Final 2020 Storage Management Plan White Paper

Comments and Responses on the June 8, 2019 Storage Management Plan White Paper

Figure 1 Comparison of Managed Storage Space Used, Managed Storage Space Available and Projected Maximum Use of Managed Storage by the Parties

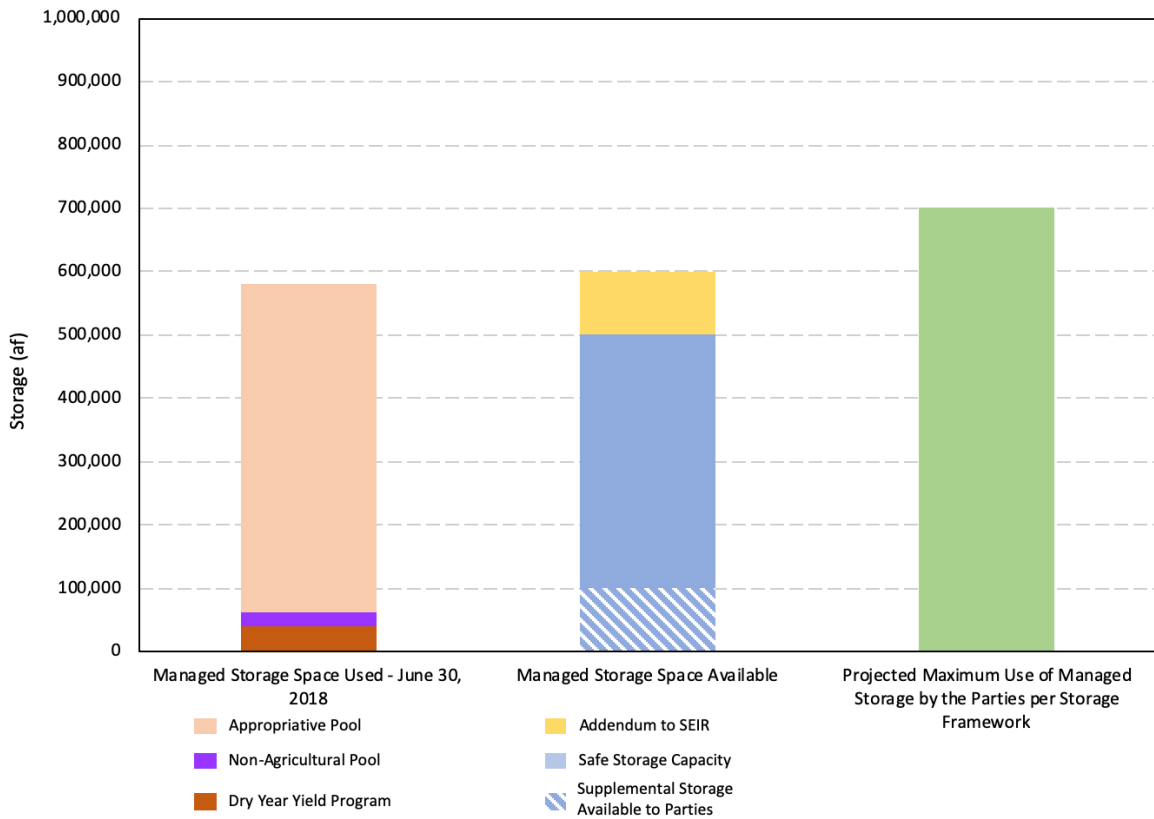
Comment No. 14. Page 9, second paragraph that reads: “Based on the best available planning information provided by the parties in the Storage Framework Investigation, the parties’ use of managed storage was projected to reach about 700,000 af in 2030 and decline monotonically thereafter. Therefore, it is logical to consider establishing a limit for the parties’ use of managed storage at 700,000 af in the Storage Management Plan.” **Ag Pool comment reads: “This seems a bit high and not specific enough to each pumper. An itemized list of each parties desire for storage would be useful. What the parties lay claim to cannot be used by water bankers including IEUA for their grant funding. Water bankers are going to want absolute certainty in what they can bank.**

Response: These comments should be addressed by the parties in the development of the 2020 Storage Management Plan.
